Q5 replacement at point 6 right

Integration proposition for new Q5R6.

Layout proposal – R6

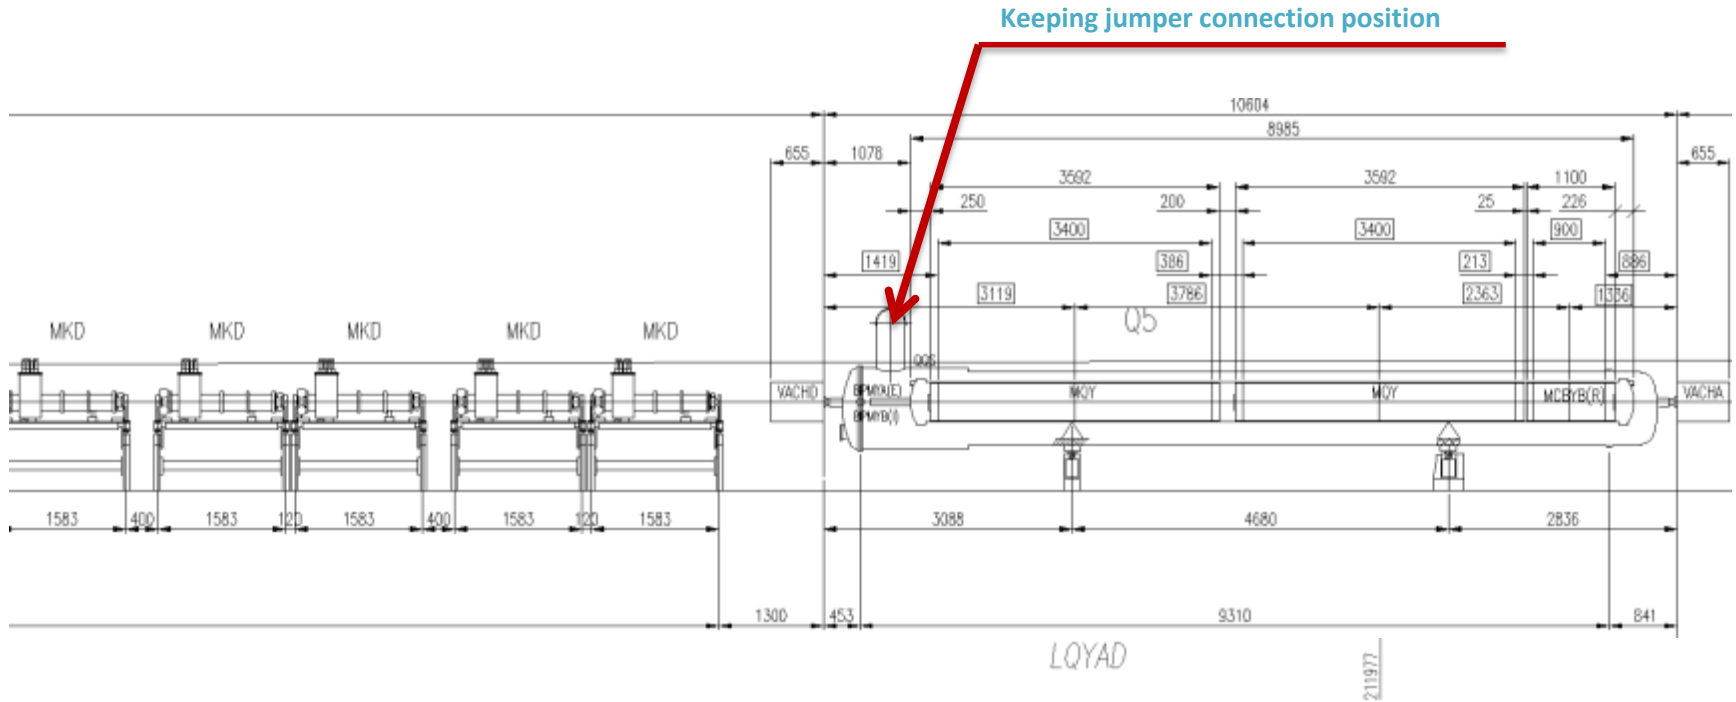
BPMY.5R6 = ~205.482 from=IP6;
 MQY.A5R6 = 208.142 from IP6;
 MQY.B5R6 = 211.928 from IP6;
 MCBY.5R6 = 214.291 from IP6;

- New Q5R6 in place

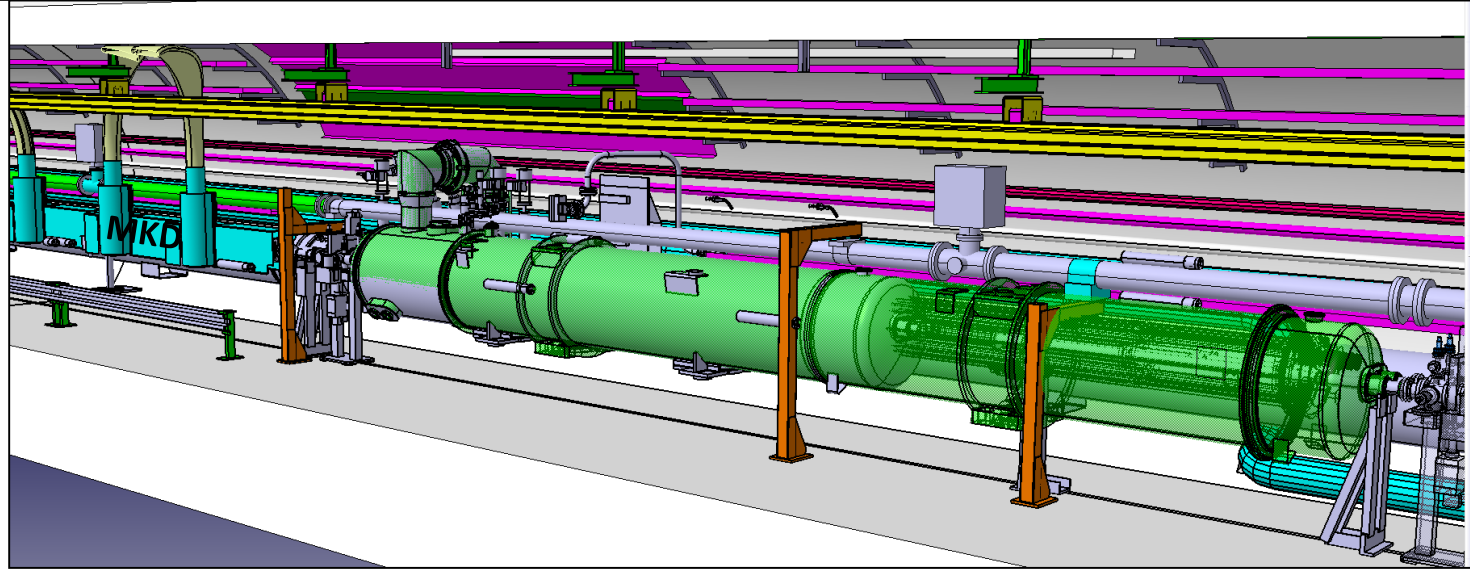
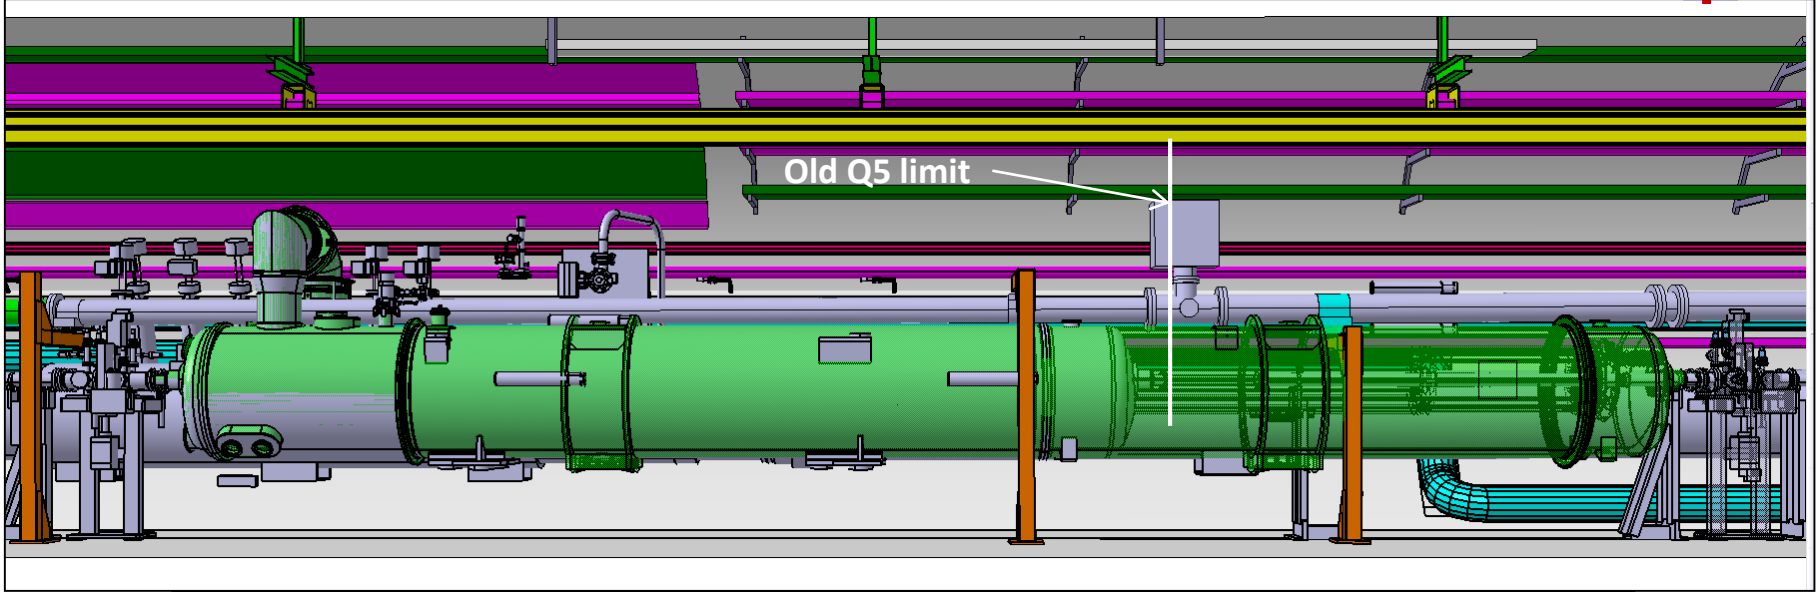
- New integration proposition

- Q5R6 integration

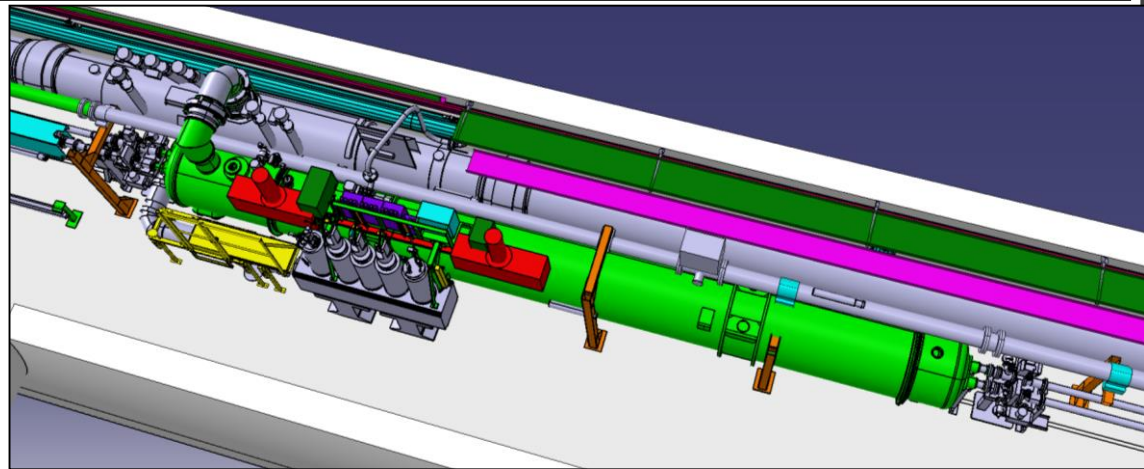
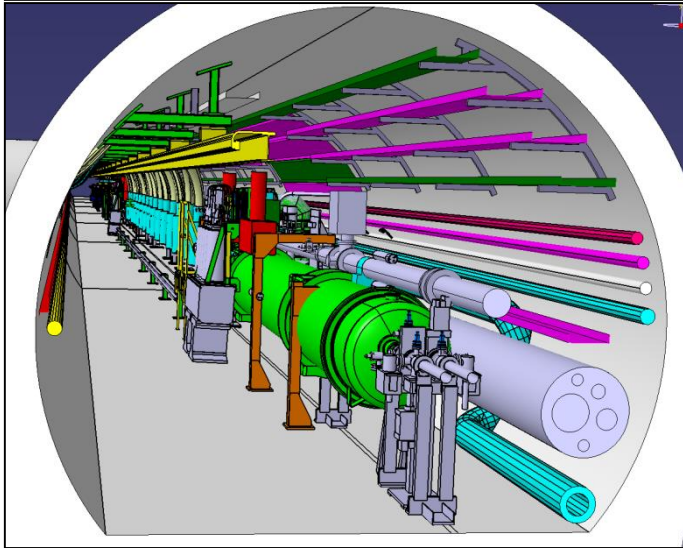
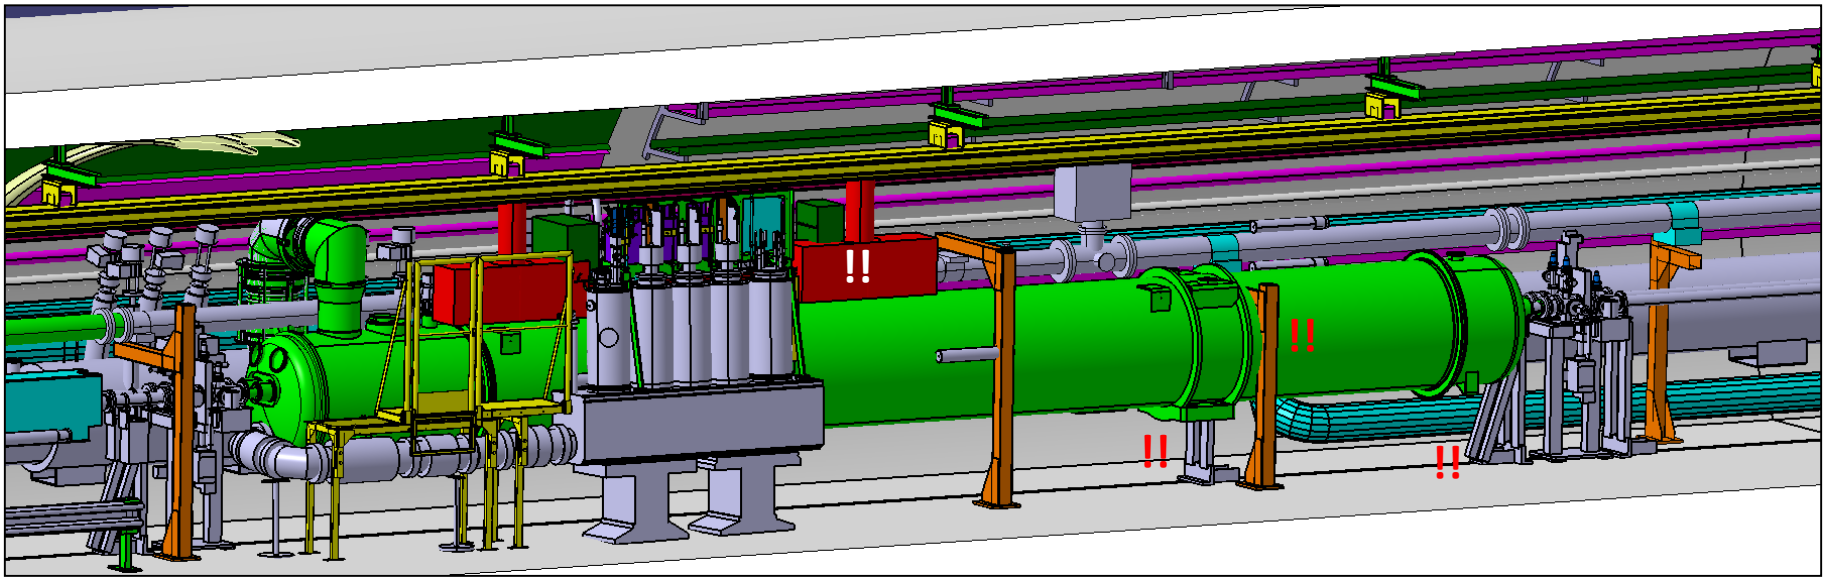
- Vacuum supports and vacuum chambers to be revised in the new Q5 sector
- At least one beam dump support to replace
- Survey space reservation to be change according to the new Q5 cryostat
- BLM position to be check (beam dump and LHC beam lines)
- No changes around DFBMM
